Palo Verde Nuclear
Generating Station

**Subject: Palo Verde Nuclear Generating Station (PVNGS)
Unit 1
Docket No. STN 50-528
Response to Request for Additional Information to Proposed
Exigent Amendment to Technical Specification 5.5.9, Steam
Generator Tube Surveillance Program**

**REQUEST FOR ADDITIONAL INFORMATION
PALO VERDE UNIT 1
TECHNICAL SPECIFICATION AMENDMENT - TUBESHEET INSPECTION
(Non-Proprietary Version)**

Figure 2-1

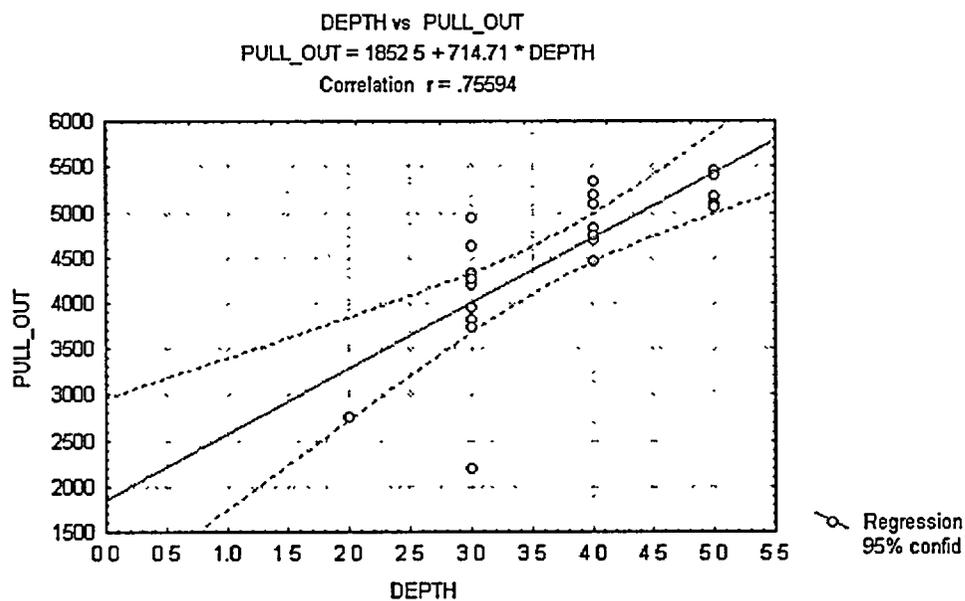
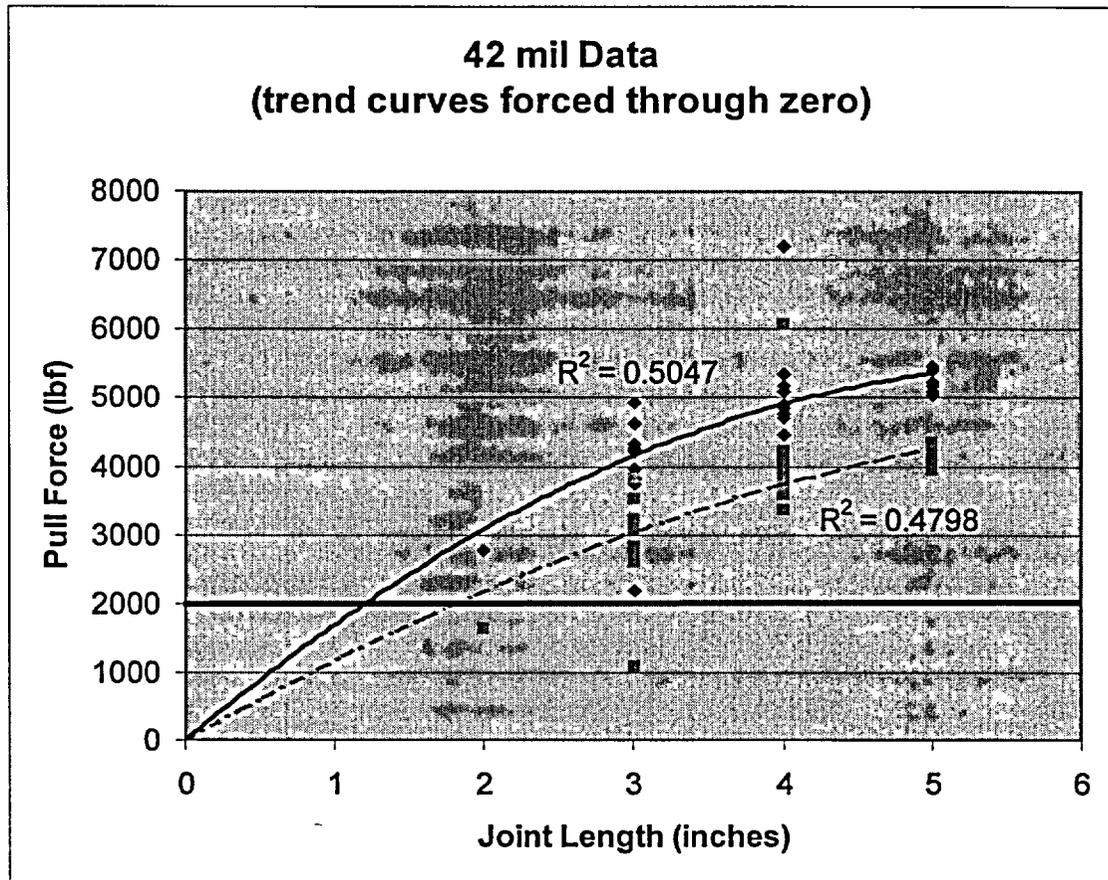
Section 6.0 of WCAP-15947-P indicates that pull test data from two single tube mockup specimens were used in the development of the average pullout load. Discuss the technical basis for assuming the average load rather than a bounding load as well as for not considering the use of the Boston Edison pull test data. Describe the impact the use of a bounding load would have on the tubesheet dilation correction factor. Please discuss the appropriateness of using the coefficient of friction of 0.2. Is this value consistent with (i.e., bound) the experimental results performed in support of the report?

With respect to tube pullout, the data (see response to *NRC Question 12*) considered most applicable to PVNGS is the 0.042 inch tube wall thickness data from the BE steam generator and single mockup Specimens 20 and 21. The applicability of this data, with respect to material, design and fabrication variability has been addressed in the PVNGS Supplemental Report and in responses to *NRC Questions 4 and 5*. This data has been plotted in Figures 2-1 and 2-2. It should be noted that the regression fit in Figure 2-1 did not change appreciably from Figure 11 in the PVNGS Supplemental Report. In order to assess the incremental contact force for the flexure analysis, Figure 2-2 provides a polynomial fit to the data anchored at zero. For Figure 2-2 the raw data were also arithmetically adjusted to develop a 95% lower bound fit (e.g., square points).

Using the information from the re-evaluation of all the 0.042 data, the tubesheet deflection data and an assessment of force contribution due to pressure, Table 2-2 was developed to reassess the axial force required for development of the tube deflection adjustment for pullout and leakage. The table column descriptions are as follows:

Figure 2-3

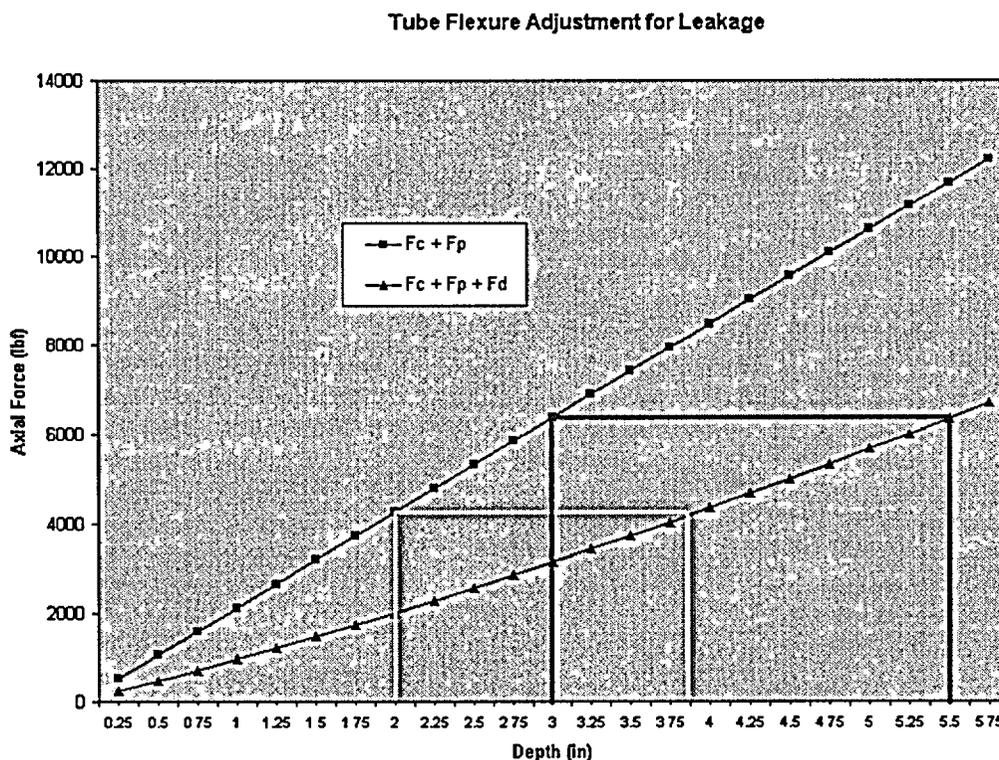
Section 6.0 of WCAP-15947-P discusses the effects of tubesheet flexure on the tube-to-tubesheet contact load. It is stated that tubesheet flexure results in a reduction of the effective contact load with the largest reduction occurring at the top of the tubesheet. Based on an analysis, the licensee concludes that at a set distance below the top of the tubesheet (i.e., the tubesheet dilation correction factor), the resisting load exceeds the bounding pullout load criteria of 2000 lbf determined at 3NODP. The licensee further states that the tubesheet dilation correction factor will provide sufficient resistance to tube pullout to meet the structural integrity requirements. The staff interprets this to mean that the distance associated with the tubesheet dilation correction factor is the minimum distance of non-flawed tubing required to prevent tube pullout. However, Section 8.0 of WCAP-15947-P implies that the distance associated with the tubesheet dilation correction factor must be added to a "tube engagement length" to determine the minimum distance of non-flawed tubing required to prevent tube pullout. Clarify this apparent discrepancy.

As indicated in WCAP 15947-P, the leakage testing on the BE steam generator samples were conducted at ambient conditions to a pressure corresponding with MSLB pressures. In that regard, the test samples were exposed to contact pressures from the expansion and the internal test pressure (F_c and F_p). From Figure 2-3, this sum is plotted per incremental depth. The effect of tube dilation is also plotted ($F_c + F_p + F_d$). The adjustment for tube dilation occurs at the normalization of these conditions such that the cumulative contact force accounting for tube dilation is equivalent to the test conditions. This adjustment for the leakage test results indicates the required engagement length. For the WCAP 15947-P engagement length for leakage (Section 8.2) of two (2) inches, the adjustment would be 1.9 inches. As indicated in APS response to *NRC Question 19*, APS has elected to use an engagement length of three (3) inches to bound the test data. The corresponding adjustment to the APS specified engagement length for leakage for tubesheet flexure as shown in Figure 2-3 as 2.5 inches. The value is listed in Table 1 of the RAI *Introduction*.

In summary, the results presented in Table 2-2 are expected in comparison to W^* . The CE joint is designed to have residual contact force at ambient conditions, and is considered more representative of a rolled joint in terms of contact pressure, and is therefore conservative to the W^* application. The test and analysis results indicate that a 2.25 inch adjustment over and above to the required engagement length for pullout provides significant conservatism. The adjustment for leakage permits a connection between the analyzed effect for tubesheet flexure and the leakage test program. This adjustment, along with test data that indicates that additional compression can be expected due to thermal expansion (not considered in Table 2-2), is also conservative. Both adjustments for tubesheet flexure in relation to the total proposed inspection length are given in Table 1 of RAI *Introduction*.

Figure 3-1 WEXTEx Joint

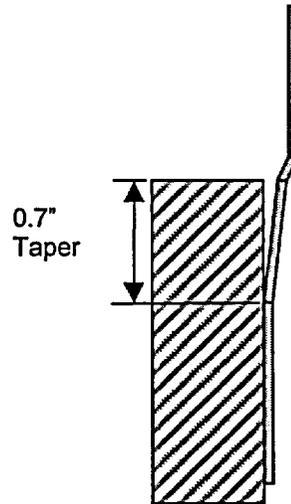
The Supplemental Report to WCAP-15947-P indicates that beginning in the Fall 2002 refueling outage (U1R10), the licensee will record the bottom of expansion transition (BET) location for all tubes. In addition, the supplemental reports states that if the BET location is greater than 0.7 inches below the top of the tubesheet then the inspection extent (i.e., 7 inches) would need to be increased accordingly. Please clarify if the BET location will account for effects due to both underexpansion of the expansion joint as well as taper of the joint. In addition, discuss whether you plan to modify the 0.7 inch value based on results from the ongoing steam generator tube inspections at Unit 1. Lastly, the commitment to increase the inspection extent under these circumstances must be incorporated into your Technical Specifications.

Both WCAP 15947-P and the PVNGS Supplemental Report make comparative statements with respect to the WEXTEX joint which contains a non-contact region defined as a taper (see Figure 3-1).

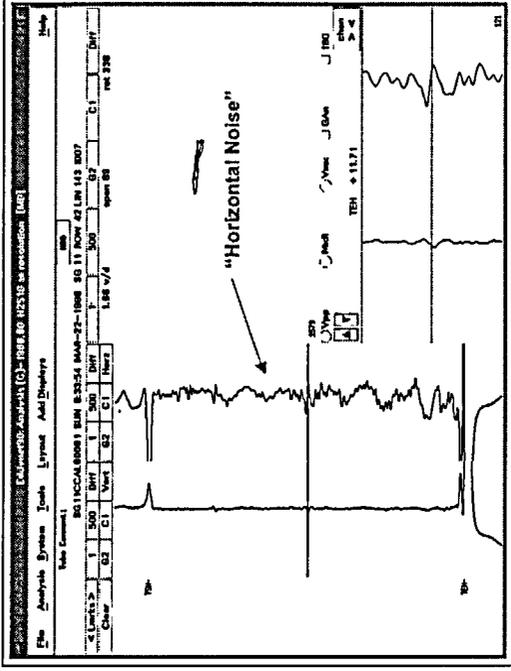
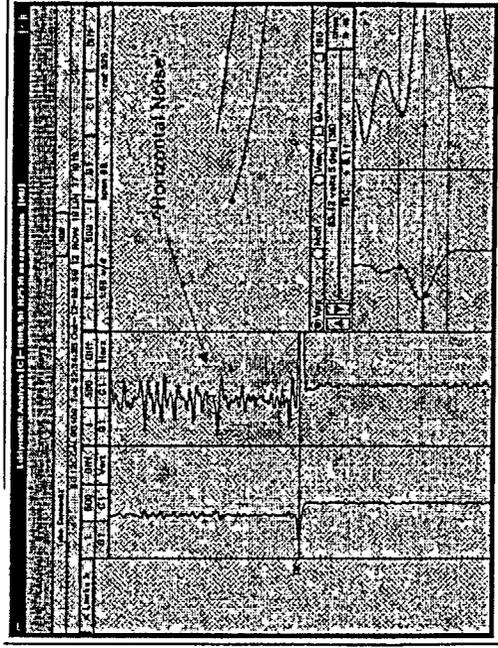
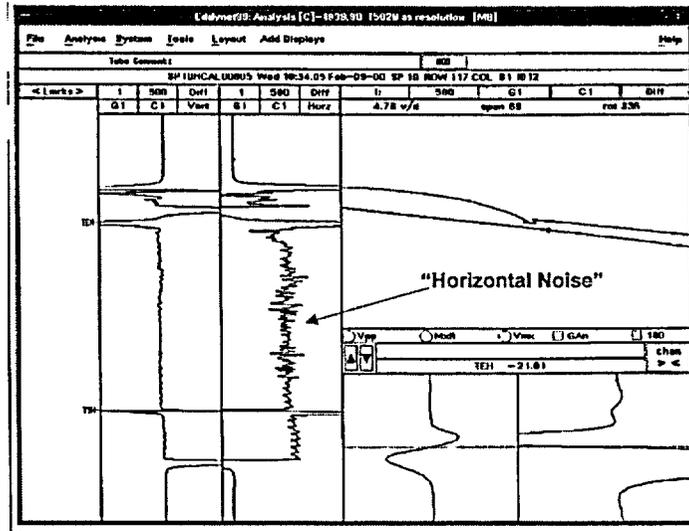
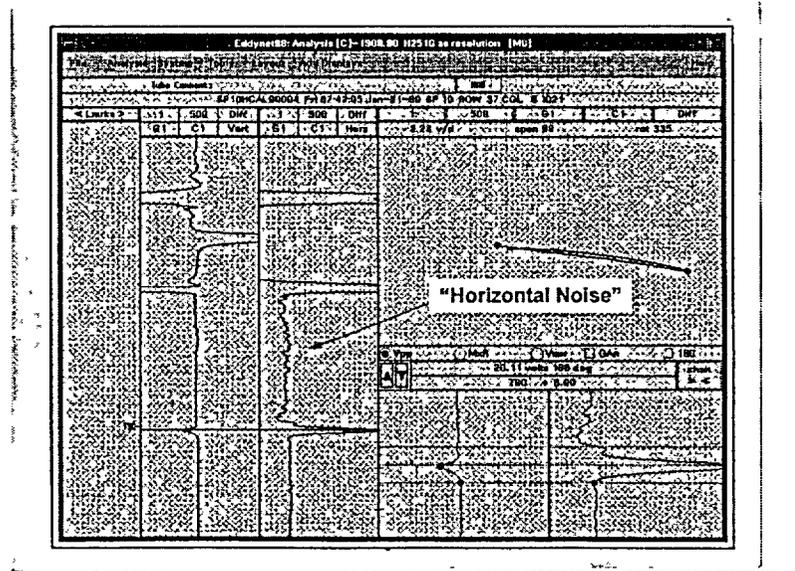
The Supplemental Report to WCAP-15947-P describes a noise evaluation that was performed to confirm that Unit 1 bore roughness was consistent with a rough bore characterization. The report concludes that the Unit 1 joints are comparable to the Boston Edison joints. Please clarify what factors or conditions were determined to be comparable.

In evaluating all six PVNGS steam generators, APS found that a distinct difference in the ECT horizontal noise signature between Unit 1 and Units 2/3. The results appear to confirm CE fabrication records indicating a change to the BTA process sometime during fabrication of the Unit 2 steam generators. APS requested similar ECT measurements of the BE steam generator and a visual comparison of the graphics indicates a similarity in horizontal noise. The BE raw data was not subjected to the same newly developed noise software, and therefore this data was not quantitatively addressed in the APS noise study. However, example graphics of a BE tube, Unit 1 tubes (including a mean level noise) and a smooth bore mock-up are provided below. These graphics are all measured at the same span for comparative purposes.

Based on this evaluation and CE records, APS concluded that the fabrication process used in the Boston Edison (BE) steam generators was the same as PVNGS Unit 1. As such, the results could be used without adjustment.

Figure 9-1

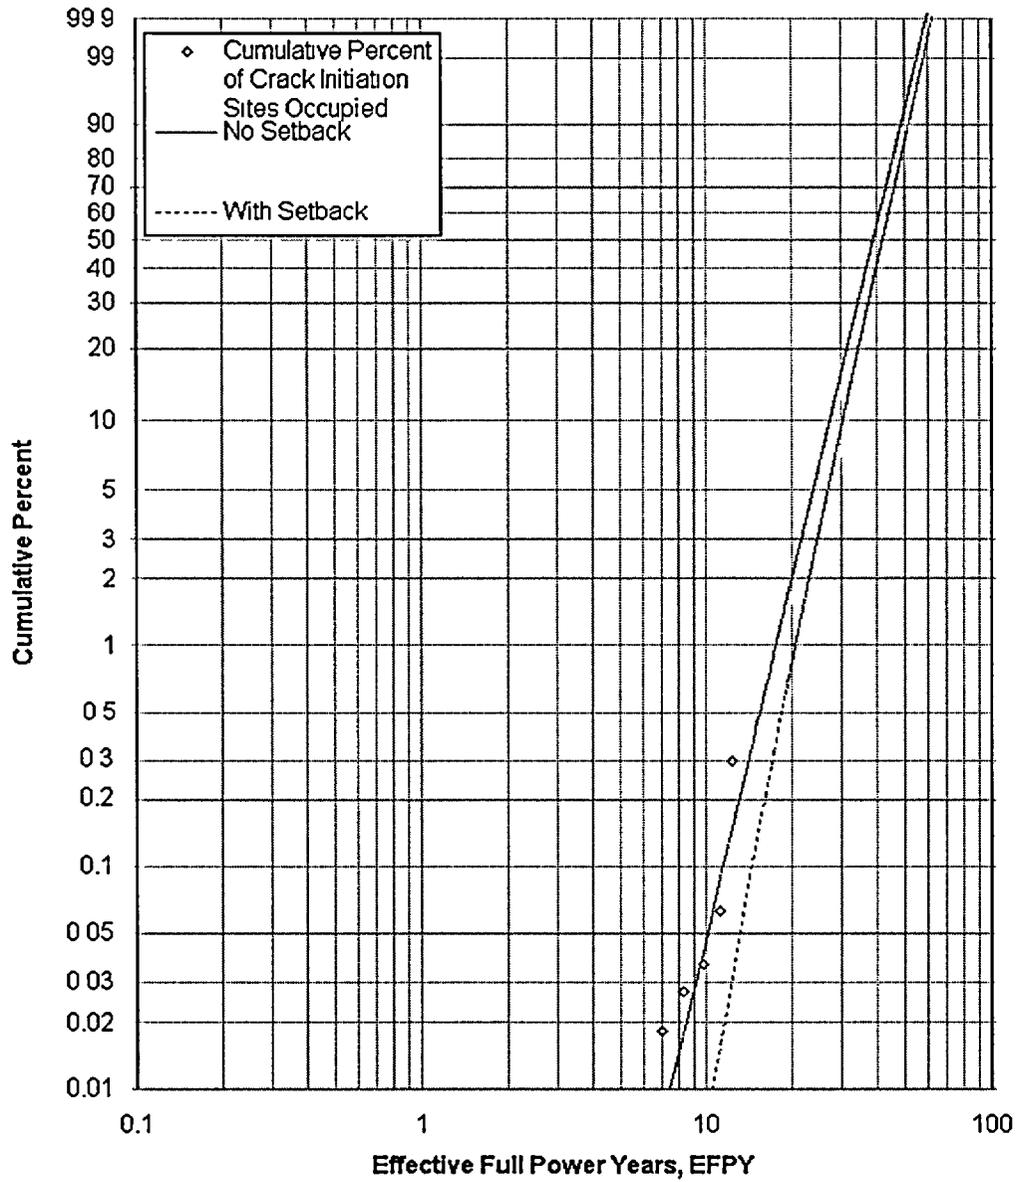
In the Supplemental Report to WCAP-15947-P, the licensee concludes that the projected number of undetected flaws in the region of the tube inspected only with the bobbin coil, at 95% probability, is significantly less than the 1100 tube assumption used in the CEOG report. Given that the licensee's projection is a current projection, and the license amendment is requested as a permanent amendment, what assurances are there that the 1100 tube assumption used in the CEOG report will remain conservative as the SG tubing in the lower region of the tubesheet continues to degrade? Why shouldn't all tubes be assumed to have the potential to leak?

The staff recommends you consider performing an analysis that predicts the number of undetected circumferential flaws that will be present when the Palo Verde Unit 1 license expires. This analysis should be benchmarked based on the current inspection results, as well as at every refueling outage, by comparing the total number of circumferential cracks detected against the predicted number of undetected circumferential cracks at the mean

The analysis (Figure 9-1) indicates that the number of predicted tubes will be below the 1100 tube assumption until 31 EFPY. Based on the current licensed life¹, the expected end of life EFPY is 30-32 EFPY based on the current EFPY (12.4) with an 80-90% capacity factor. It should be noted that the expected capacity factor for Unit 1 should the existing steam generators last until end of life should be less than this assumption, based on plugging projections and maintenance issues associated with Alloy 600 MA steam generator tubing.

As such, the 1100 tube assumption in WCAP 15947-P is considered reasonable for an end of life prediction for Unit 1.

Figure 18-1

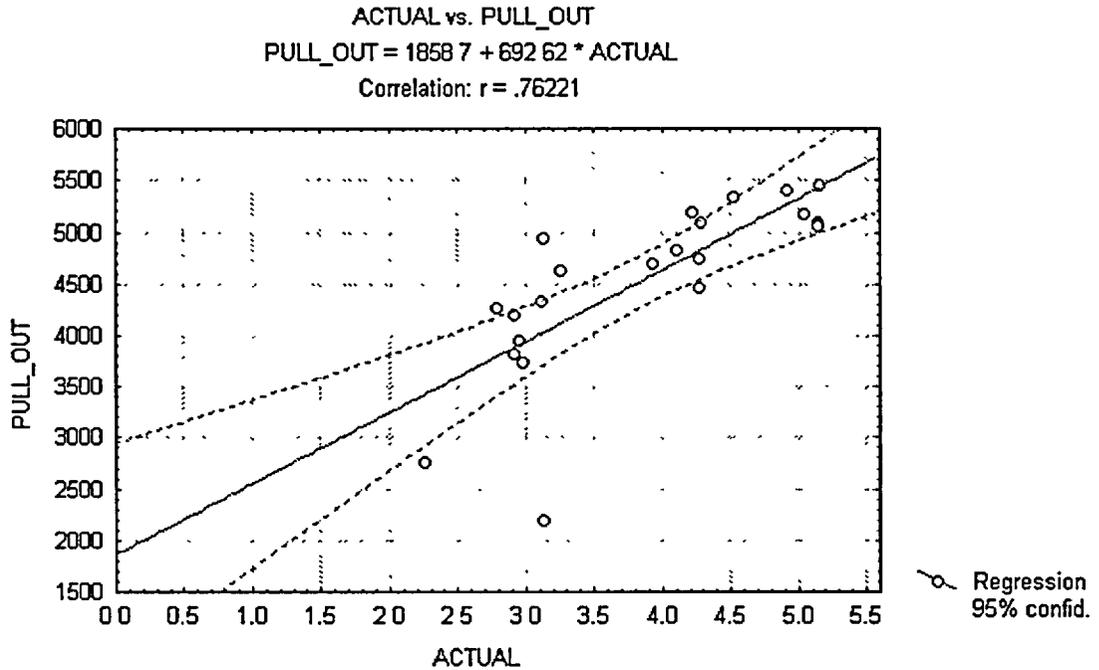
The tables in Sections 4.0 and 5.0 of WCAP-15947-P list Target Length and/or Actual Length. Explain what the Actual Length signifies. Why are actual lengths not provided for all data points? The Actual Length for Specimen number 21, which had an unexpectedly low pull out force, is not provided. Provide the Actual Length for this specimen, if possible, as it is the data point driving the 3.0 inch joint length depicted in Figure 11 of the Supplemental Report to WCAP-15947-P. It would be particularly in helping the staff understand whether the recorded pull out force for Specimen 21 is conservative or non-conservative.

A review of the test records indicates that actual lengths are available for Specimens 20 and 21. These are provided in Table 12-1 of APS response to *NRC Question 12*. A few actual lengths of the BE steam generator samples were located and entered in Table 12-1 as well. Also, the third column in WCAP 15947-P, Appendix B, entitled *Position (in) @ Force = 0* is the distance the tube was pulled before the load cell reading decreased to essentially zero. This should be a number close to the actual joint length, limited by the accuracy of the MDM head positioning and the data acquisition rate. APS evaluated these results with for a comparison with Figure 2-1 of APS Response to *NRC Question 2*. The results (Figure 18-1) indicate little change in the regression fit. The correlation improves somewhat, and the results continue to support the conclusions of WCAP 15947-P and indicate that the minimum engagement length of three (3) inches conservatively bounds the 95% confidence fit. Although, the actual length of Specimen 21 failed to provide any additional insight as to why the pullout load deviated significantly from the other data, APS believes that the discussion provided in APS responses to *NRC Questions 4, 5, and 12*, provide substantial evidence that the CEOG test data from the BE steam generator is the most applicable to PVNGS Unit 1. However, APS elected to include the results from all testing, including Specimen 21 in specifying minimum engagement length

Figure 19-1

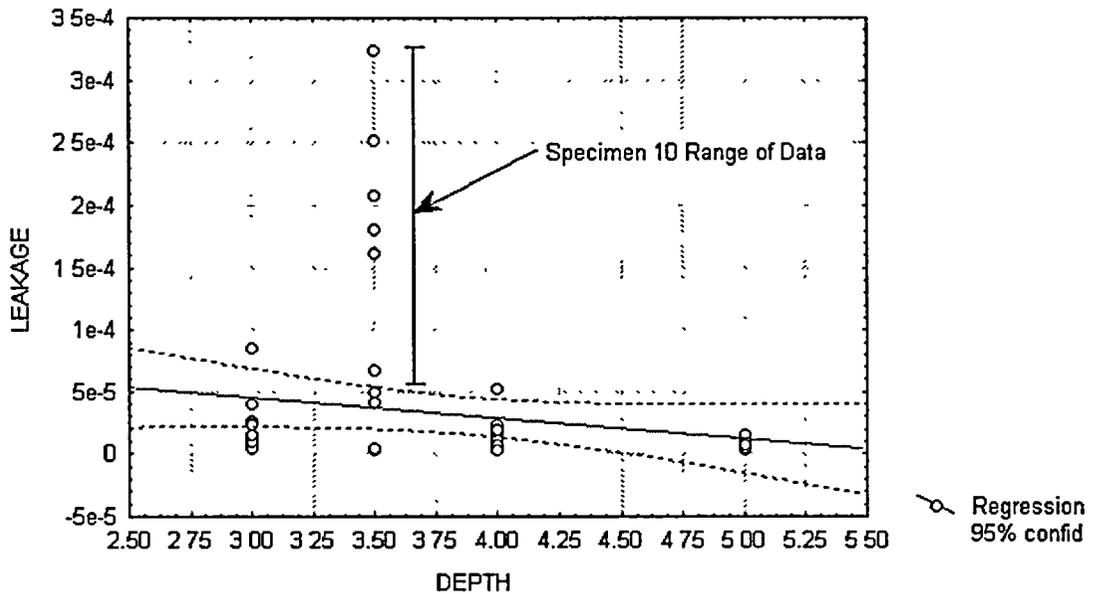
In Table 5-1 and Figure 5.1 of WCAP-15947-P the expected trend (increase in joint length results in a decrease in leak rate) does not appear to have occurred. Discuss the need for additional testing to explain the lack of a trend. Do you believe that the testing already completed has bound the largest potential leak rate?

As indicated by the NRC Staff, Figure 5.1 of WCAP 15947-P does not indicate a leak rate vs. joint length trend. However, APS believes that several observations can be made through a review of all the leakage data. Figure 5.1 of the WCAP and Figure 12 of the PVNGS Supplemental Report plot the average leak rate for the three (3) tests performed on each specimen. Additionally, APS in Figure 19-1 included the results of all the BE steam generator leak tests, as well as all the leakage test data from the single tube mockups. Although the 0.048 inch single tube mockup data is not considered applicable without adjustment for pullout criteria, the differences in tube wall thickness should not impact the leakage results. Plotting all the test data provides little improvement for relationship of joint length vs. leakage for the range of joint lengths tested. However as opposed to Figure 5.1, the test results illustrate that the leakage trend is flat for three (3) inch joints or longer with most values near the minimum level of detection for the CEOG test program.

Figure 19-1 also provides strong evidence that the data from Specimen 10 is not consistent with the rest of the data from over 60 data points. Additionally, as indicated the data spread for Specimen 10 ranges from a low of 4.13e-5 gpm to a high of 3.24e-4 gpm. An explanation for this anomaly could not be identified, although it was noted that the lower values were observed during a later test date. The most likely explanation for the outlier behavior is a bore surface finish that is uncharacteristic of the rest of the BE and rough bore mock-up samples. However, pull test data was not available for Specimen 10. Based on the outlying, variable and inconsistent nature of Specimen 10 results, APS concludes that the evidence supports removal of the ambient temperature test data for Specimen 10 from consideration.

The data presented in Figure 19-1 indicates that the contact forces due to expansion and internal pressure provide a satisfactory leak limiting joint at a three (3) inch joint length. As shown, the data is fairly flat for the 3, 3.5, 4 and 5 inch test samples, and most of the results are near the minimum level of detection for the test program. Furthermore, the major variability in the results is believed to be due to the test procedure itself. The test flow rates as described in Section 3.1.2 of WCAP 15947-P relied on counting pump strokes of a small capacity positive displacement pump over a minimum 40 minute test period. If no pump strokes were observed, a single pump stroke was assumed in order to include a flow rate in the dataset. Additionally, pump strokes were evaluated over the entire test period with no consideration as to when the positive displacement pump stroked during the test period. With most of the test data based on 0-4 pump strokes, considerable variability is introduced for such low leak rates.
